Access Compliance Report Public Rights-of-Way (Pedestrian Signals)

Main Street: WINDMILL_AVE Cross Street: ANTONIO_PKWY Location: N

ADA ID: SGRK211029135542 Signal Type: Two Push Buttons-APS Overall Compliance: No Severity Scores: BTN 1: 25 BTN 2: 25 No BTN: N/A

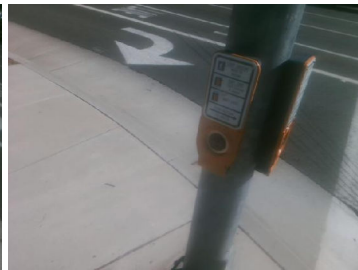
Possible Solutions: Replace Signal Push Button With APS Button. Remove & Relocate Sign. Remove and Replace Clear Space.

OC Std/PROW: MUTCD 4e.08, R404.2
